Beck Park Expansion – Phase 1

Bid # 25-11

ADDENDUM No. 2

April 10, 2025

sheet name
**OVERALL MATERIALS
PLAN**

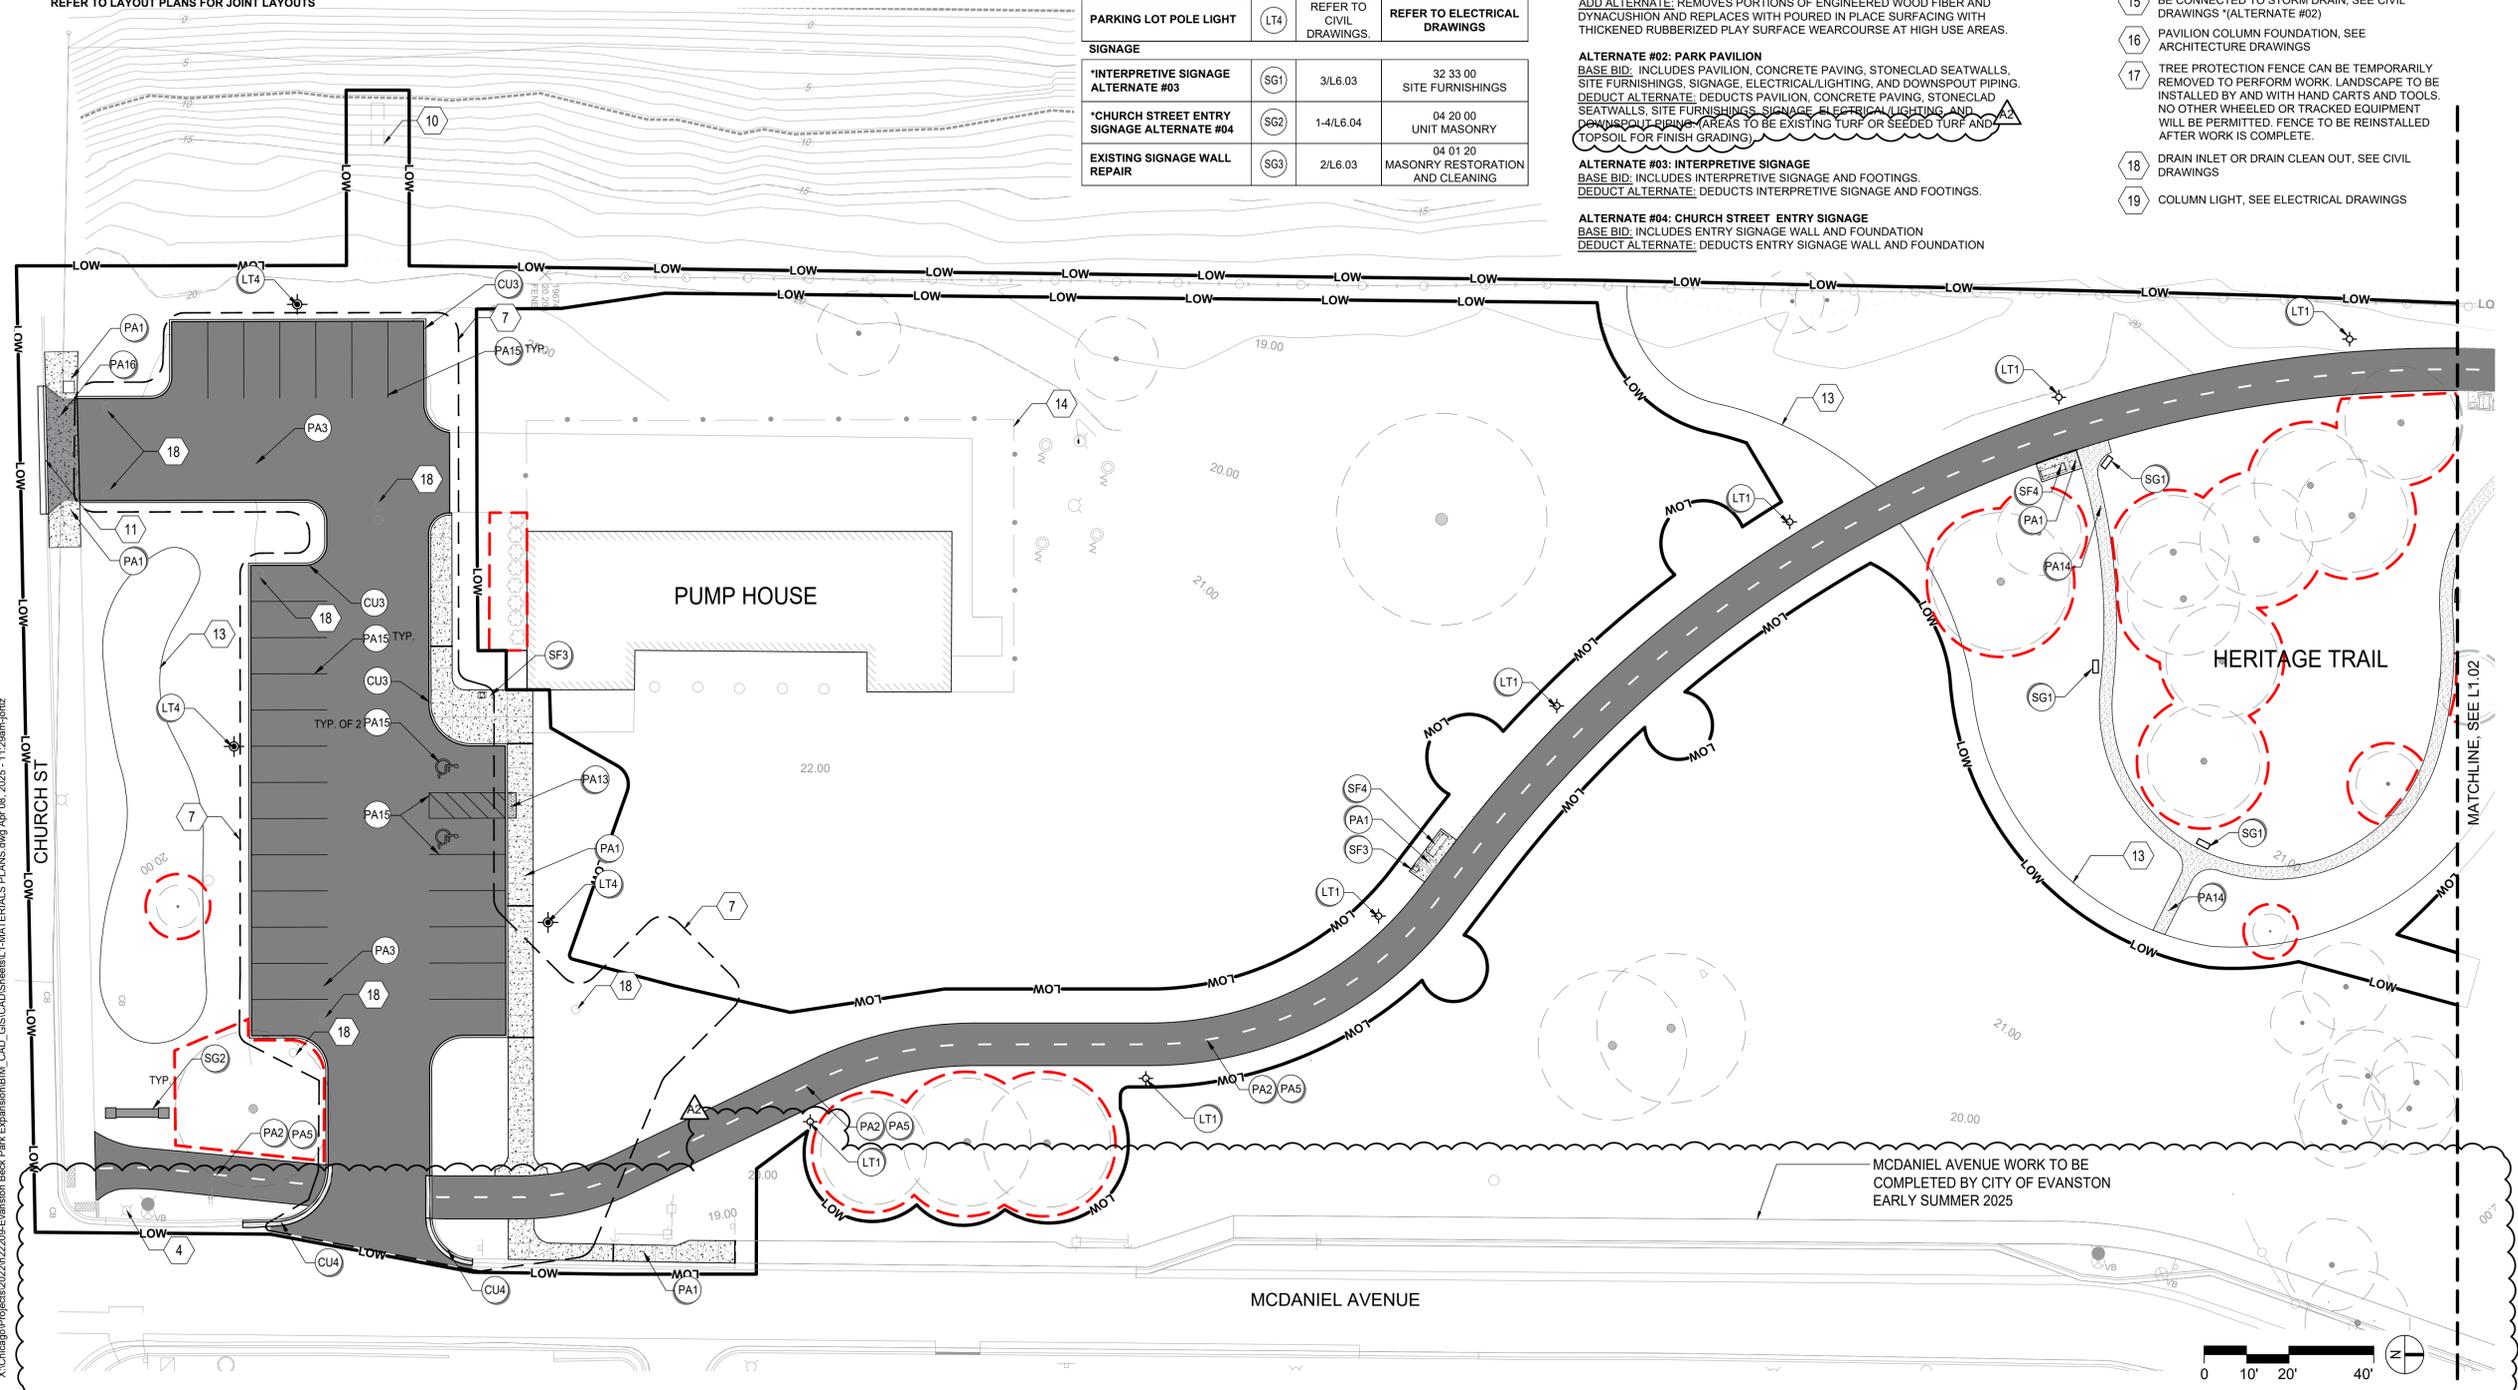
Sheet L1.00 Overall Materials Plan

- McDaniel Avenue Street Project (By City of Evanston) added, for reference
- Sidewalk connection to McDaniel Avenue Street Project added

sheet name
MATERIALS PLAN

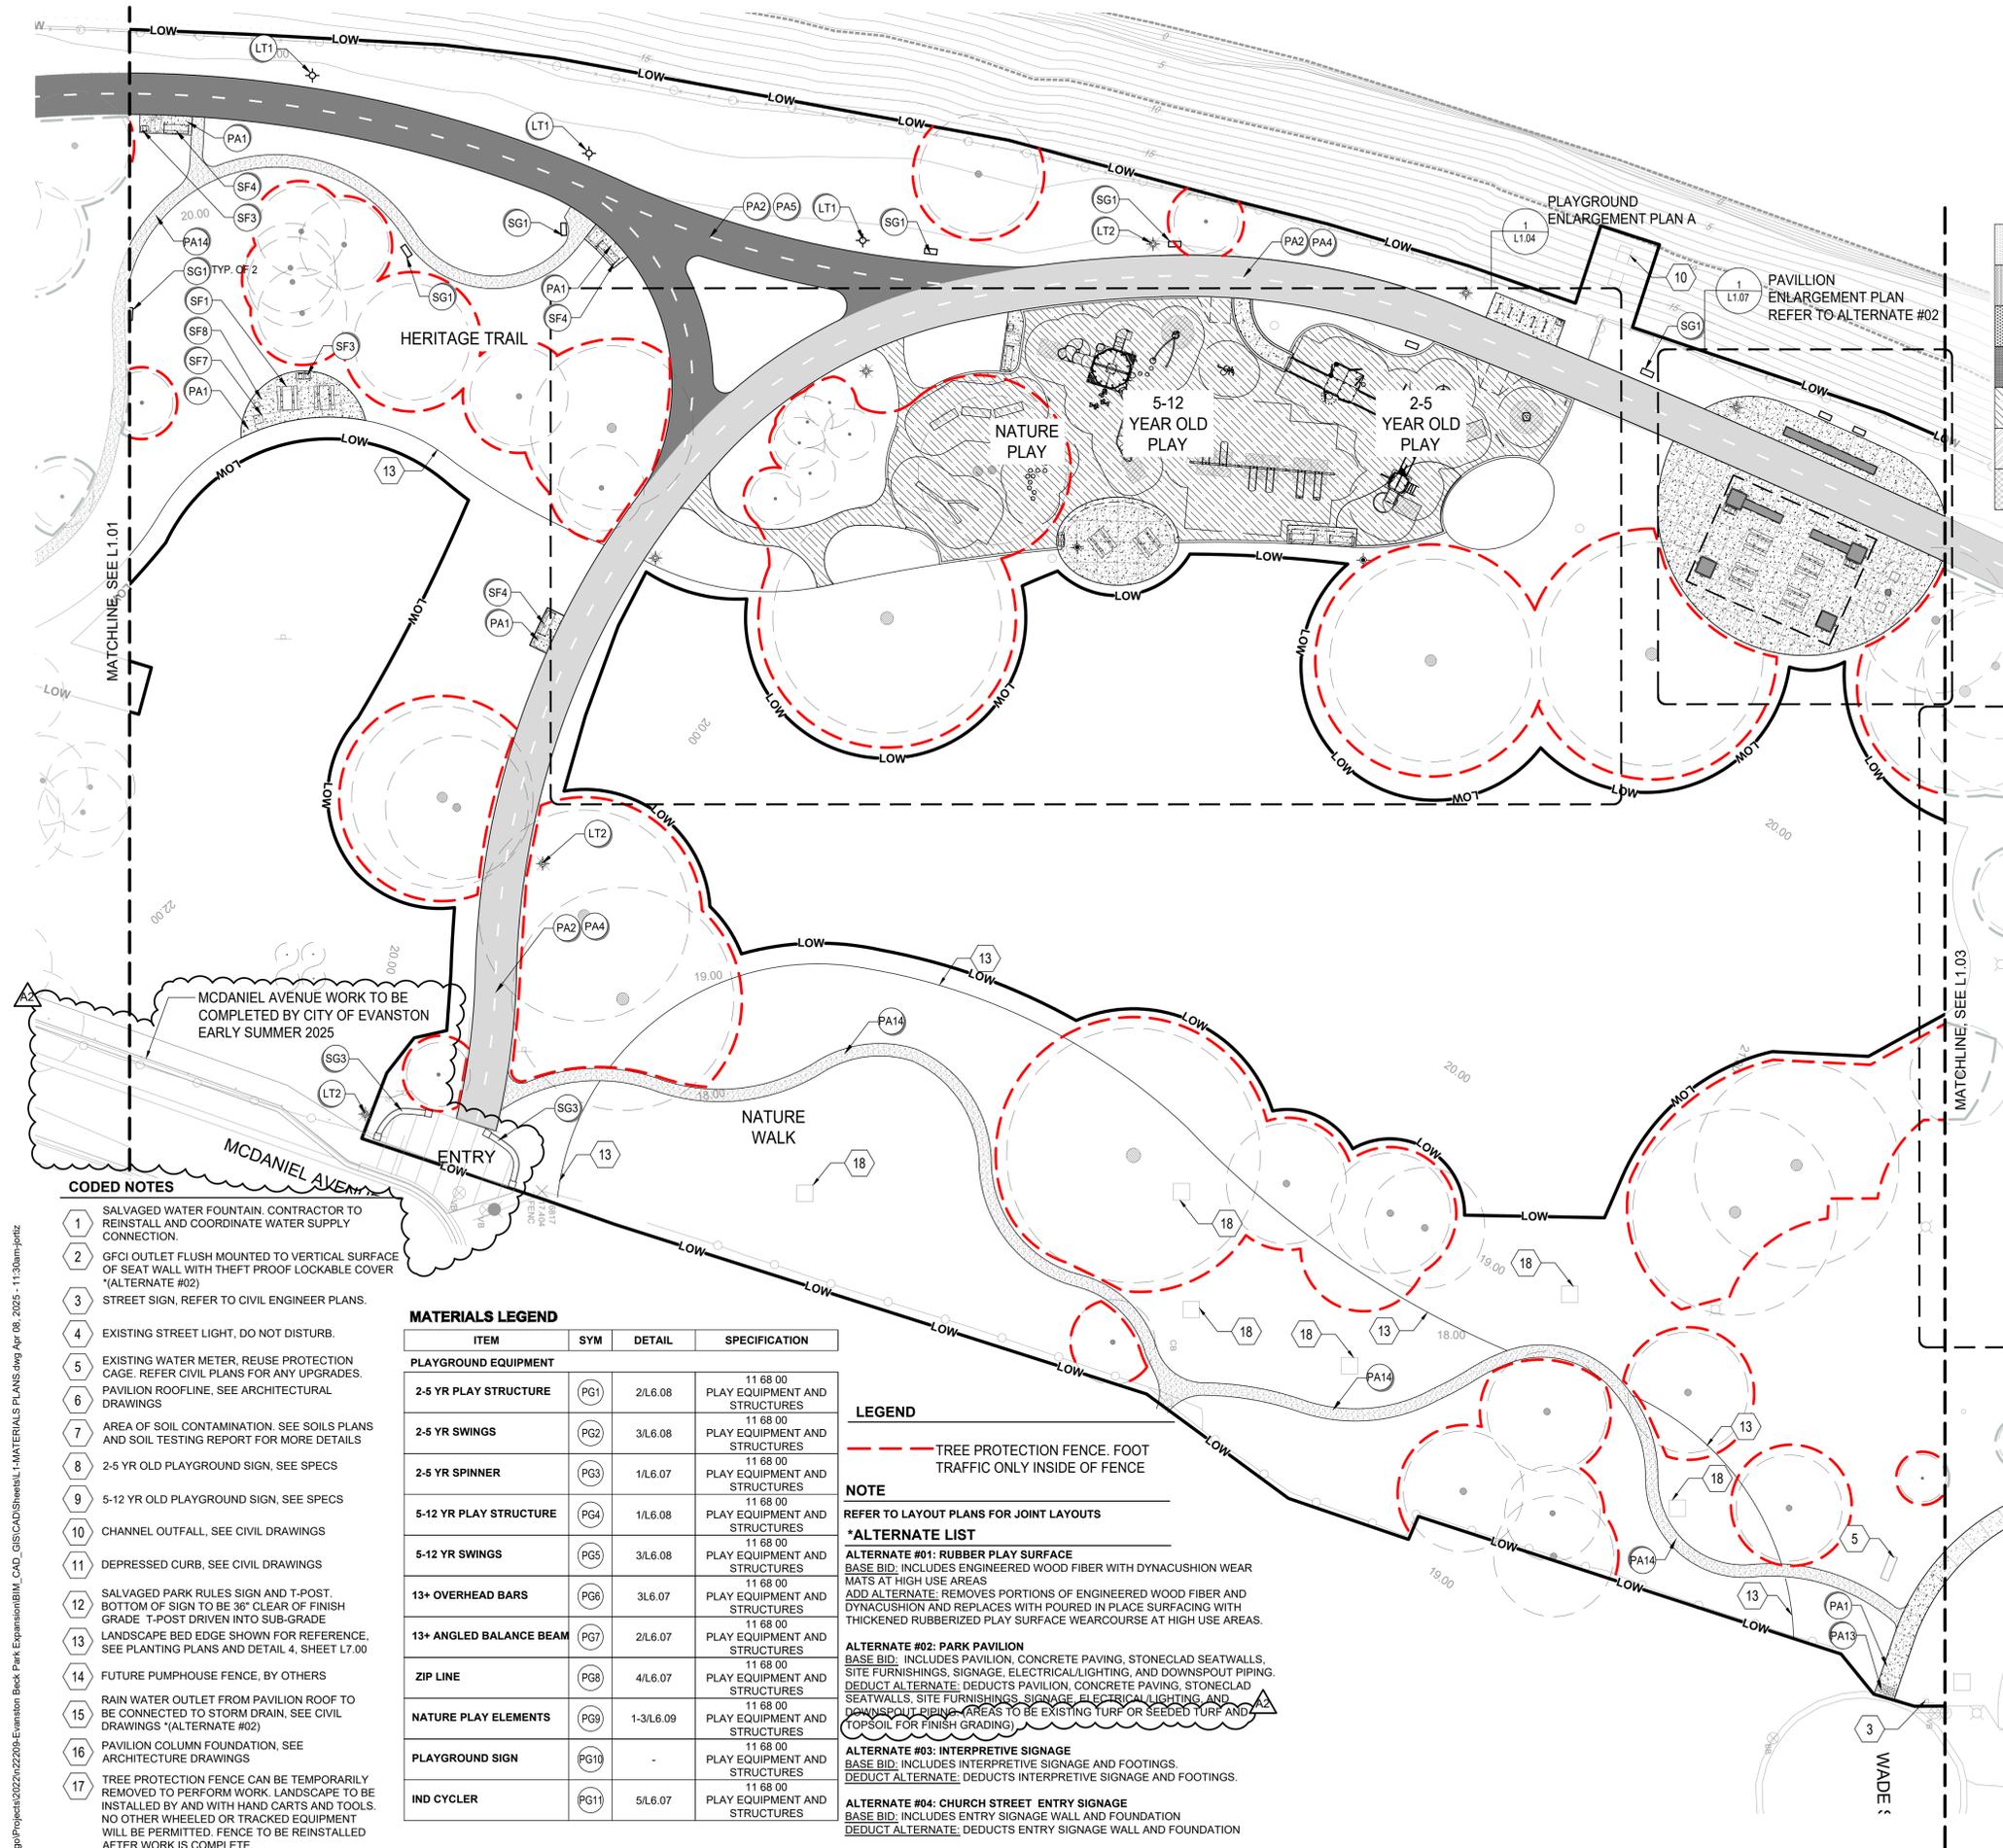
Sheet L1.01 Materials Plan

- McDaniel Avenue Street Project (By City of Evanston) added, for reference
- Sidewalk connection to McDaniel Avenue Street Project added
- Alternate #02 text clarification
